**DOT/FAA/ND-00/1**

# **Heliport/Vertiport Design Deliberations 1997 - 2000**

14. Sponsoring Agency Code	
15. Supplementary Notes					
16. Abstract  During the last several years, the FAA has been working toward the revision of both the Heliport Design advisory circular, AC150/5390-2B, and the Vertiport Design AC, AC150/5390-3. This work has been done in cooperation with Industry via meetings, discussions, and working papers. This report documents some of the some of the more significant issues that have been discussed during the 1997 to 2000 time period.  While heliports and vertiports are different, many of the design issues are similar. Indeed, the FAA has previously announced its intentions to combine the two advisory circulars (AC) into one AC. This is why both subjects are addressed in the same report.

Figure 3

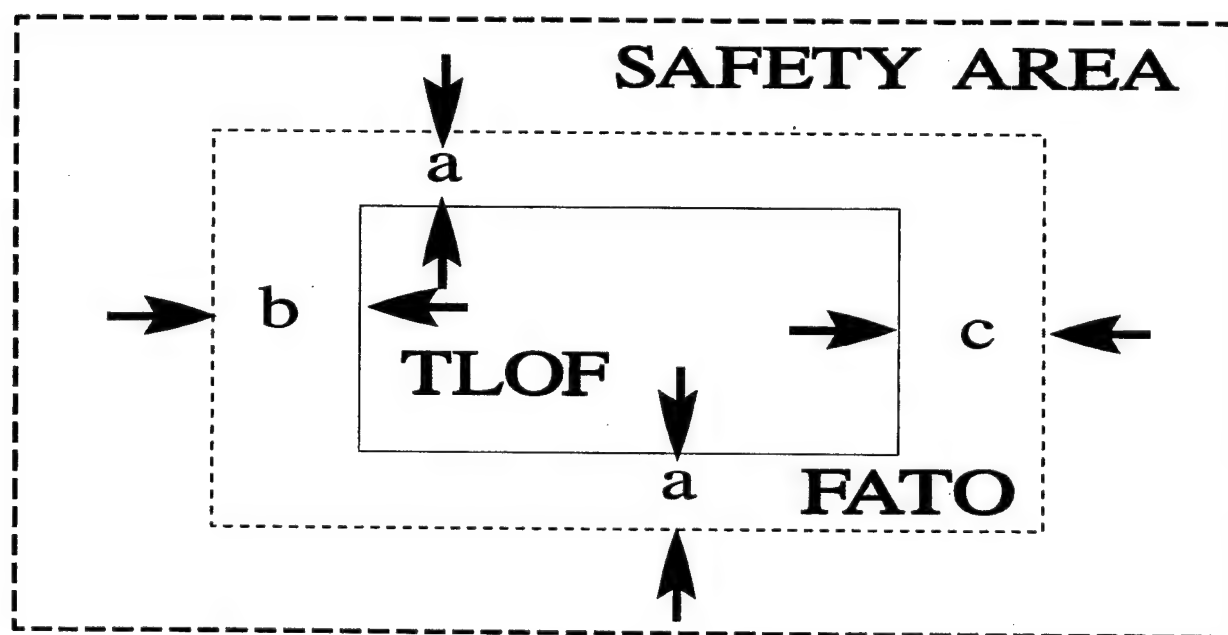
One WG member suggested that the dimension "a" was intended to account for an off-center landing. Another WG member suggested that it was intended to provide obstacle clearance. Several members commented that they did not know the purpose of the protection area designated by dimension "a".

Figure 4-1. Typical vertiport marking and lighting

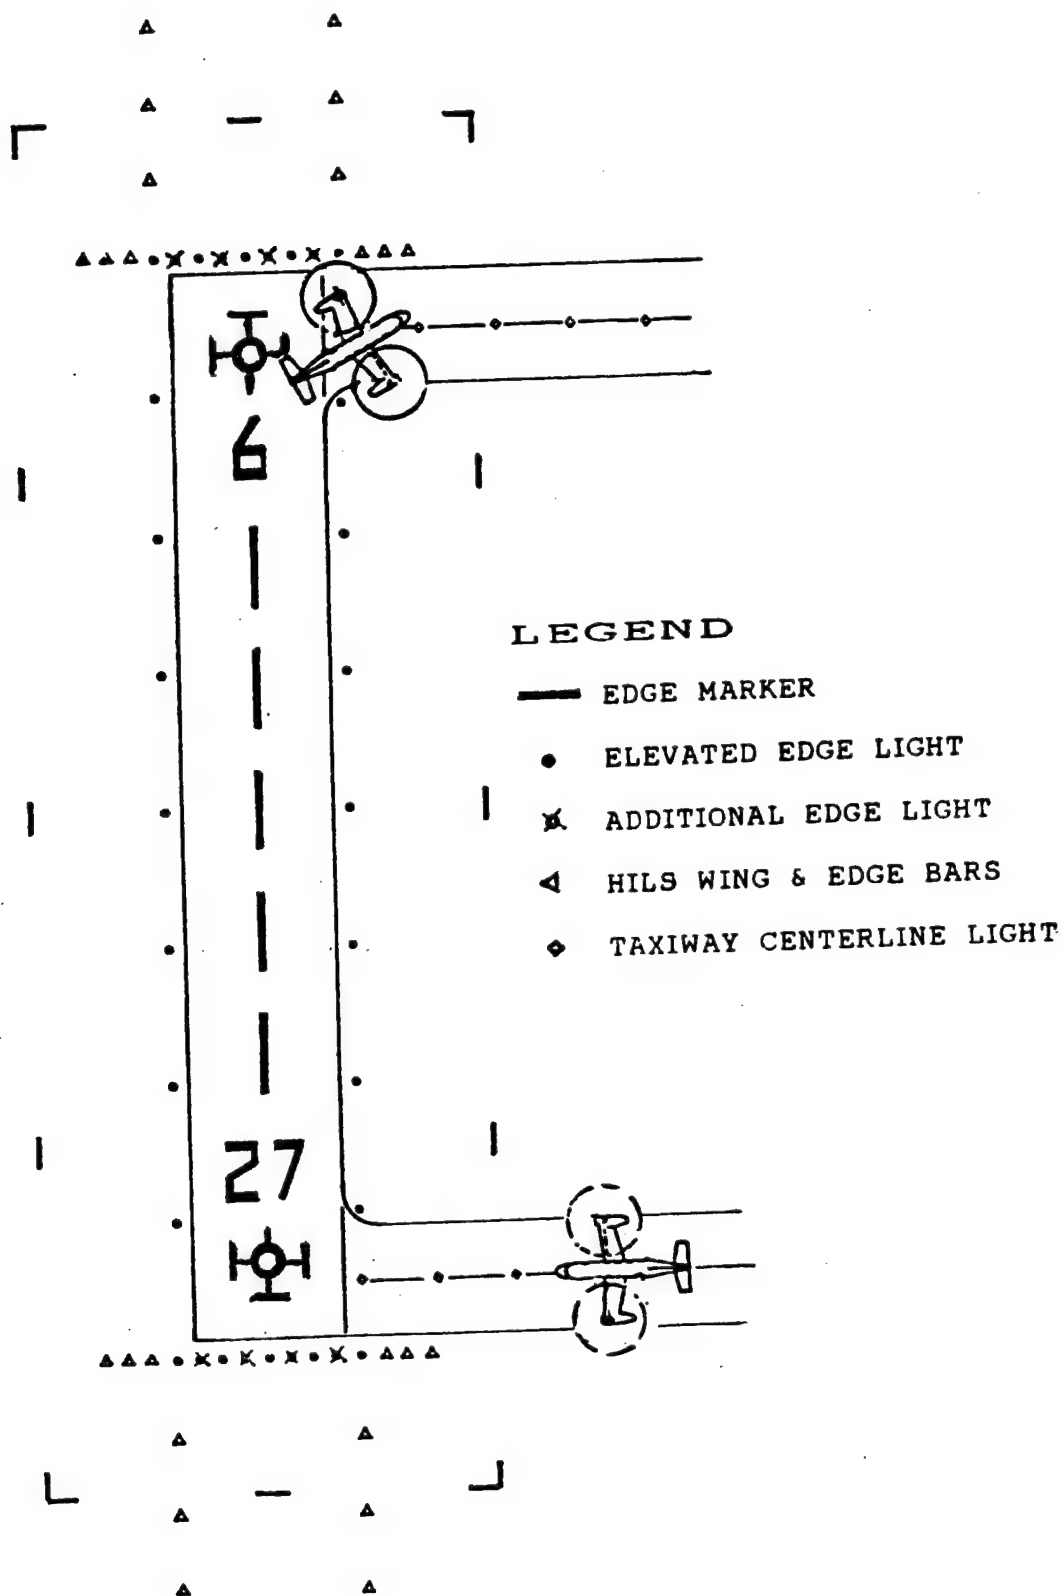
AC150/5390-3, Vertiport Design, shows several illustrations of vertiport TLOF azimuth markings. Figure 4-1, Typical Vertiport Marking and Lighting, is a notable example (shown later in this white paper). However, the advisory circular (AC), says little about the dimensions and the exact placement of these azimuth markings. The following is an excerpt from paragraph 41b(1):

If the simulation pilots found the 28 foot vertiport marking symbol to be inadequate, one can imagine what they would have said about a 14 foot vertiport azimuth marking. However, in this simulation effort, NASA used TLOF azimuth markings consistent with the size and proportions recommended in AC150/5340-1G (60 feet tall). The question now at hand: "Is the guidance developed for 3 degree runway approaches also optimal for approaches to vertiports or is some alteration appropriate?"

Figure 1. Comparison of the Current 1 : 8 Approach/Departure Surface and the Two - Slope Approach/Departure Surface (Two Approach/Departure Paths)

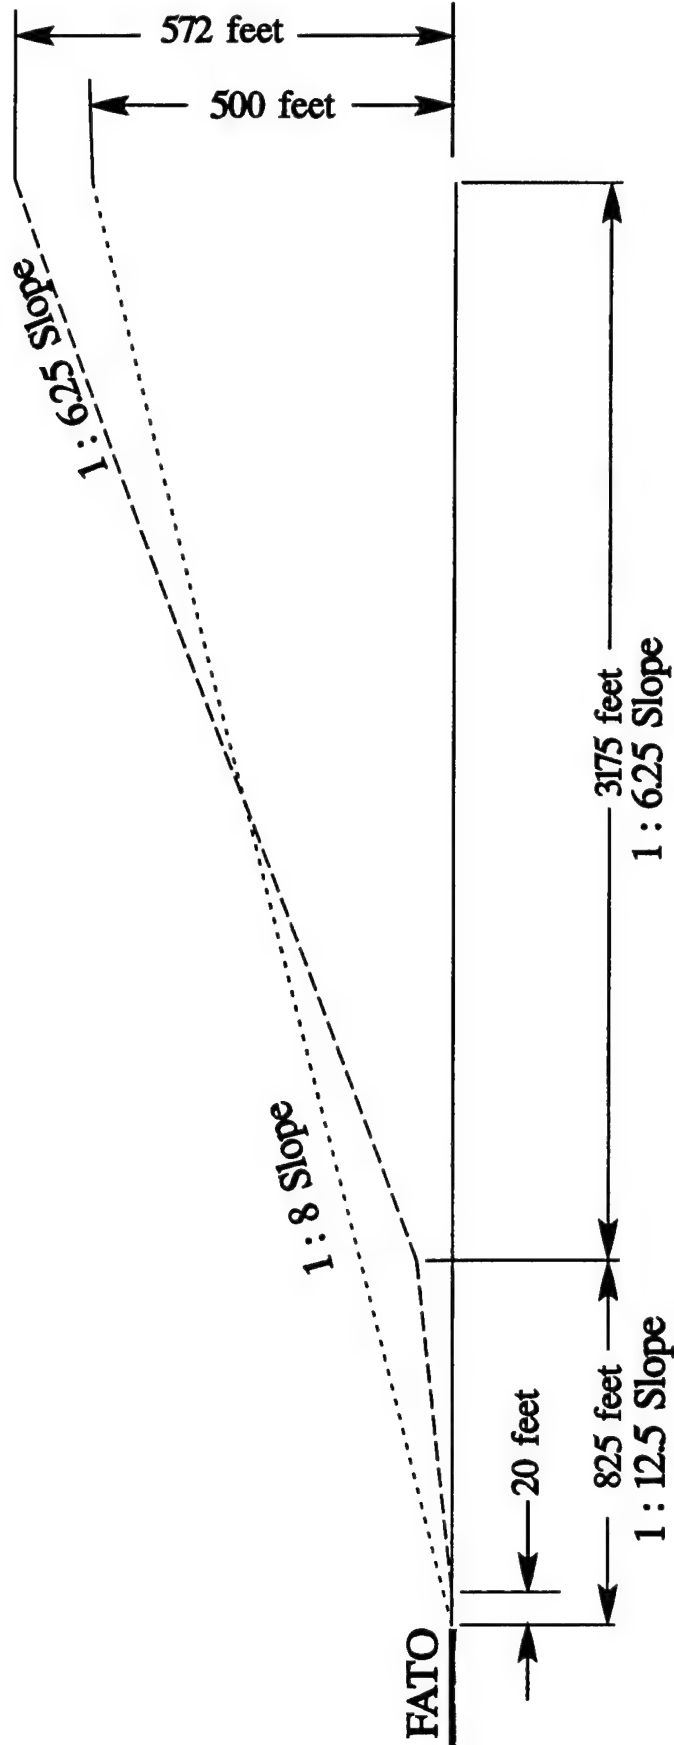
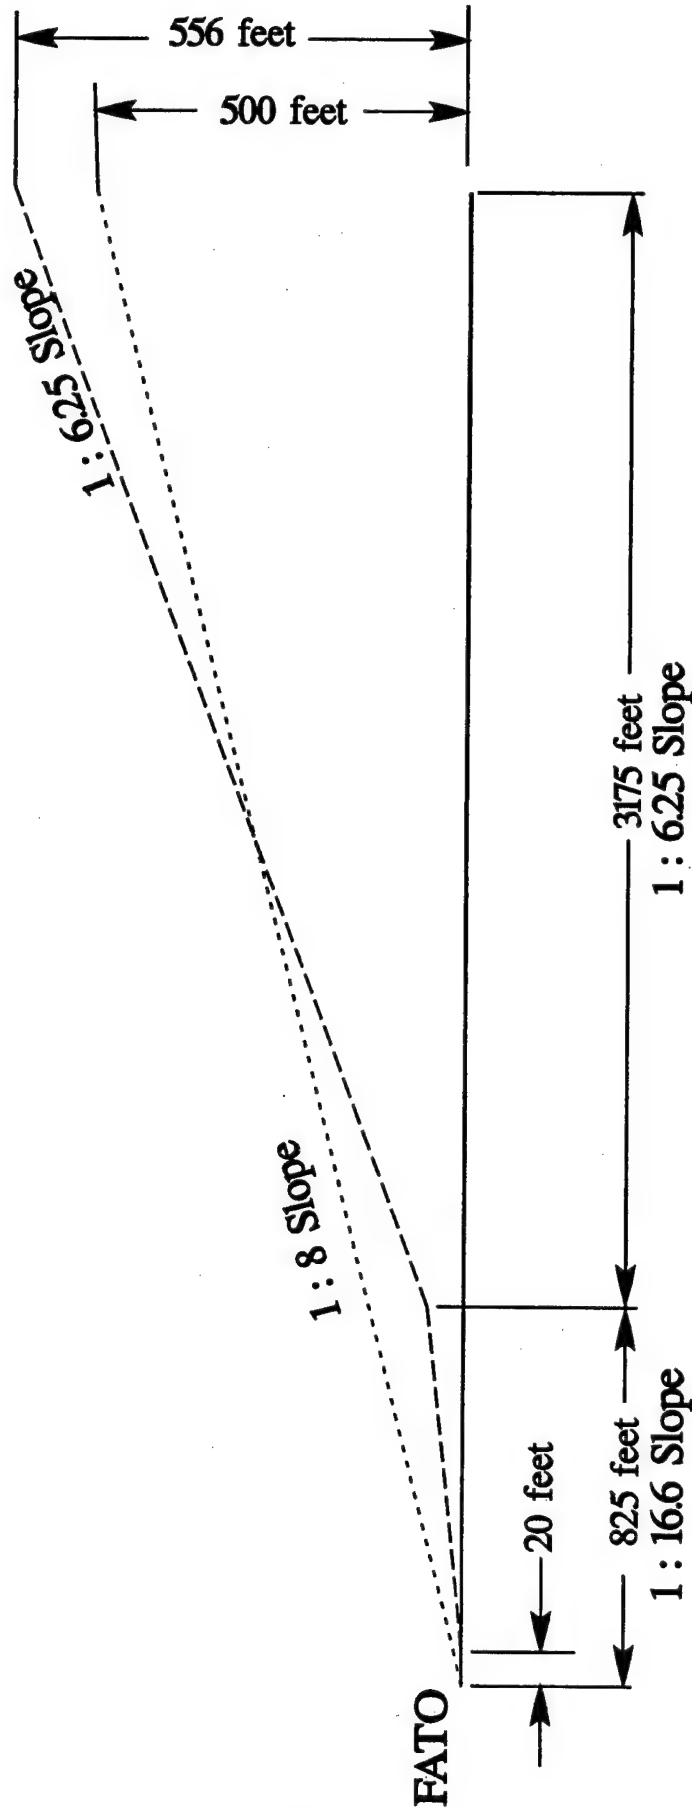
Subsequently, Industry has proposed that AC150/5390-2B be modified to require **only one** approach/departure path at the vast majority of heliports in the nation and that Figure 1 should also apply in such cases. This is an unappealing proposal. Transport Canada's rationale for distinguishing between these two scenarios is sound; it is a simple matter of physics. Helicopter performance deteriorates in the presence of a tailwind. At a heliport with **only one** approach/departure path, the pilot will sometimes be forced to operate with a tail wind. To maintain an adequate safety margin under such a scenario, the additional airspace of Figure 2 is recommended. At the same time, the FAA recognizes that many existing heliports only have one approach/departure path and that a second path is impossible to obtain. How can the FAA

The FAA would strongly prefer to adopt both figures 1 and 2 as Transport Canada has done. Figure 1 would be for heliports with two approach/departure paths (separated by 150 degrees or more). Figure 2 would be for heliports with only approach/departure path. Unfortunately, we have been unable to reach a consensus on this point with Industry. As a compromise, the FAA and Industry have agreed to adopt figure 1. While this is less than ideal, it does provide an additional safety margin in comparison with the current Heliport Design AC recommendations. This additional airspace would also provide operators with additional operational flexibility.

Figure 1. Comparison of the Current 1 : 8 Approach/Departure Surface and the Two - Slope Approach/Departure Surface (Two Approach/Departure Paths)

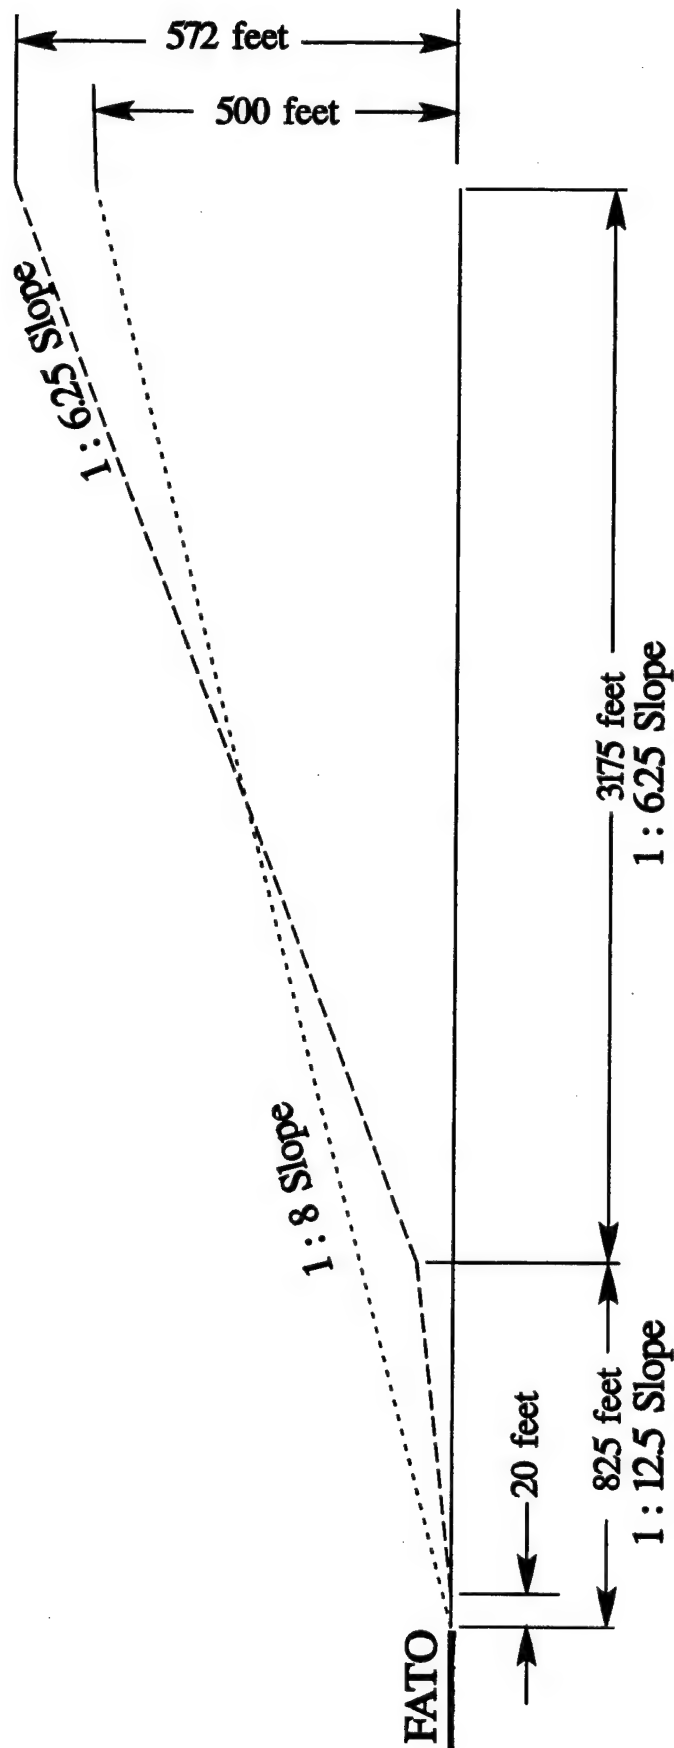
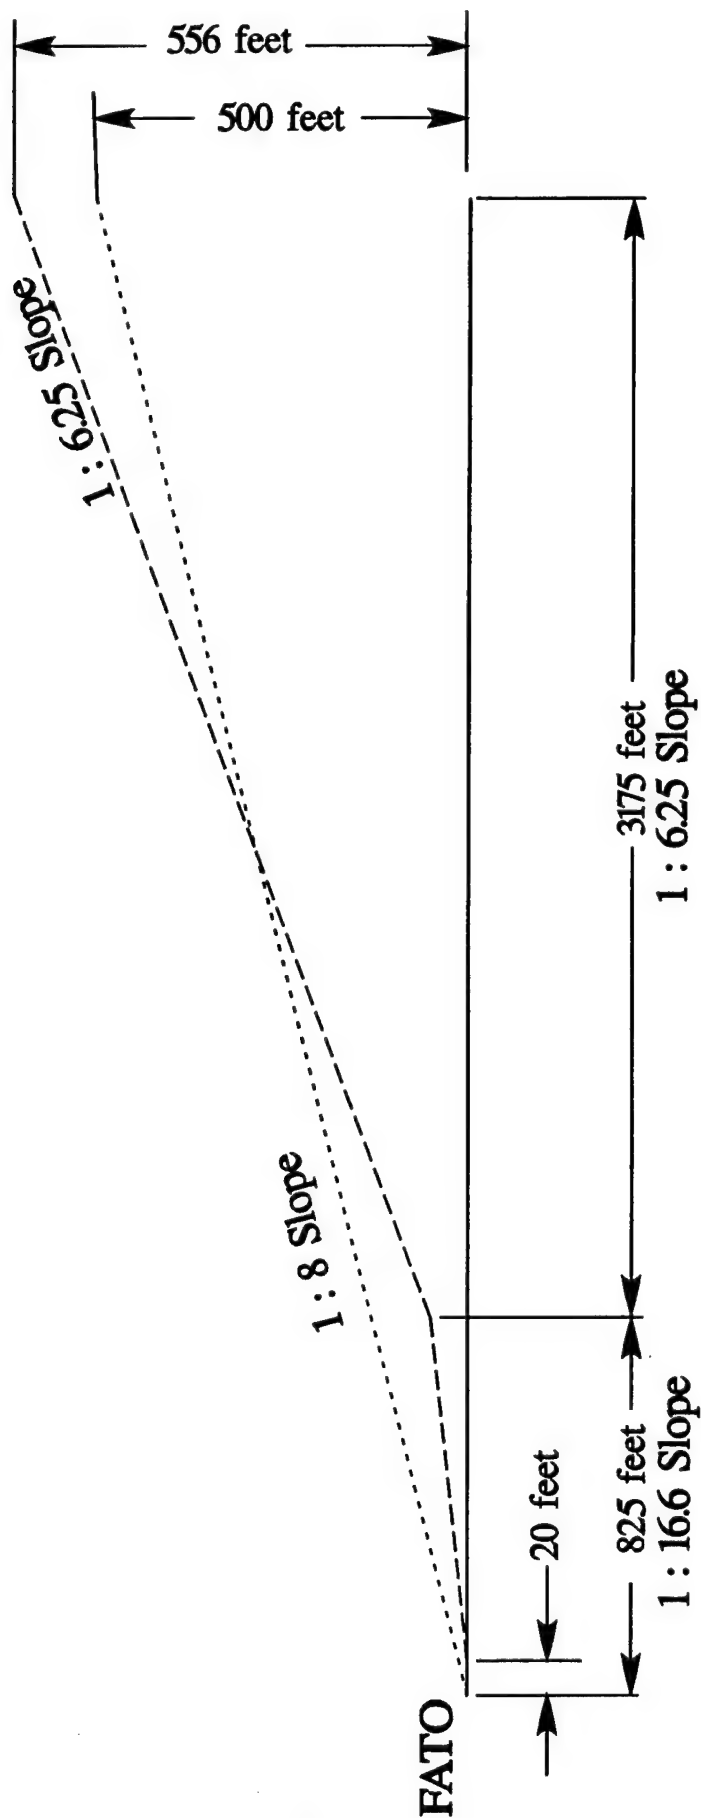
Subsequently, Industry has proposed that AC150/5390-2B be modified to require only one approach/departure path at the vast majority of heliports in the nation and that Figure 1 should also apply in such cases. This is an unappealing proposal. Transport Canada's rationale for distinguishing between these two scenarios is sound; it is a simple matter of physics. Helicopter performance deteriorates in the presence of a tailwind. At a heliport with only one approach/departure path, the pilot will sometimes be forced to operate with a tail wind. To maintain an adequate safety margin under such a scenario, the additional airspace of Figure 2 is recommended. At the same time, the FAA recognizes that many existing heliports only have one approach/departure path and that a second path is impossible to obtain. How can the FAA encourage new facilities to be designed with two approach/departure paths without inadvertently encouraging state aviation authorities to close all current heliports with only one path?

The FAA would strongly prefer to adopt both figures 1 and 2 as Transport Canada has done. Unfortunately, we have been unable to reach a consensus on this point with Industry. As a compromise, the FAA and Industry have agreed to adopt figure 1. While this is less than ideal, it does provide an additional safety margin in comparison with the current Heliport Design AC recommendations. This additional airspace would also provide operators with additional operational flexibility.
